4.0 Building C2

4.2 Revised Scheme

4.4 Revised Scheme - C1 + C2 Roof Plan

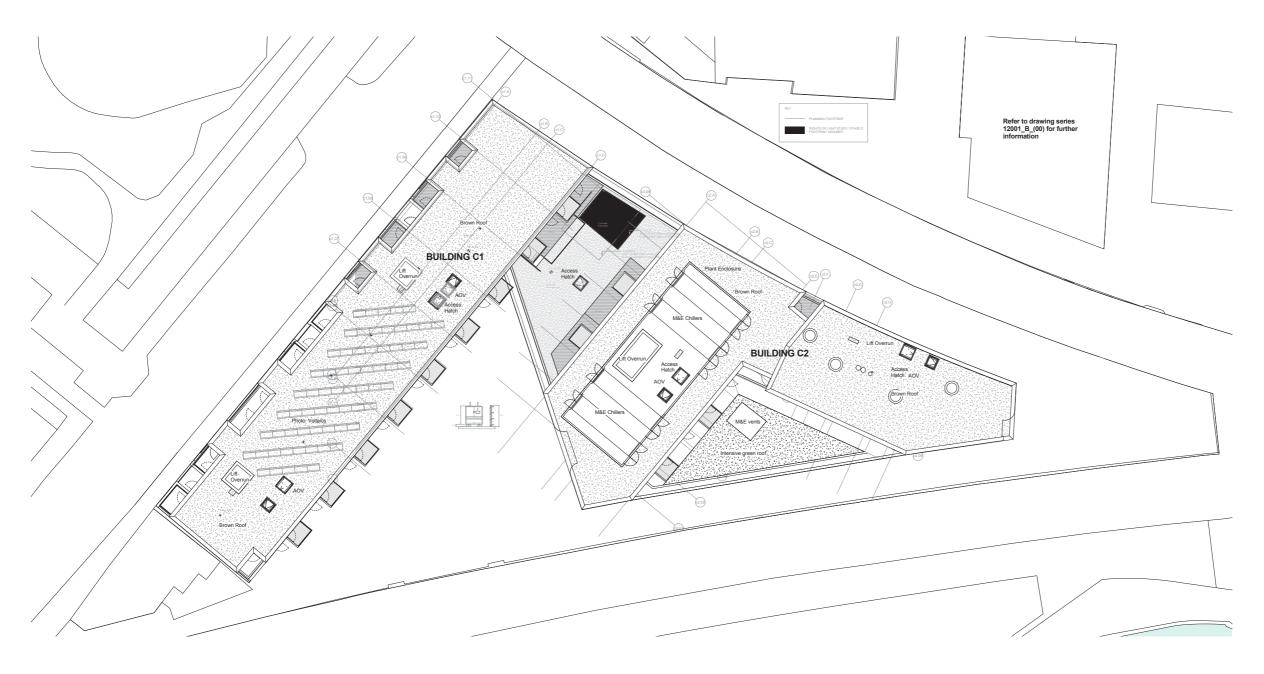
1) Flues increase in height by 1.5m.
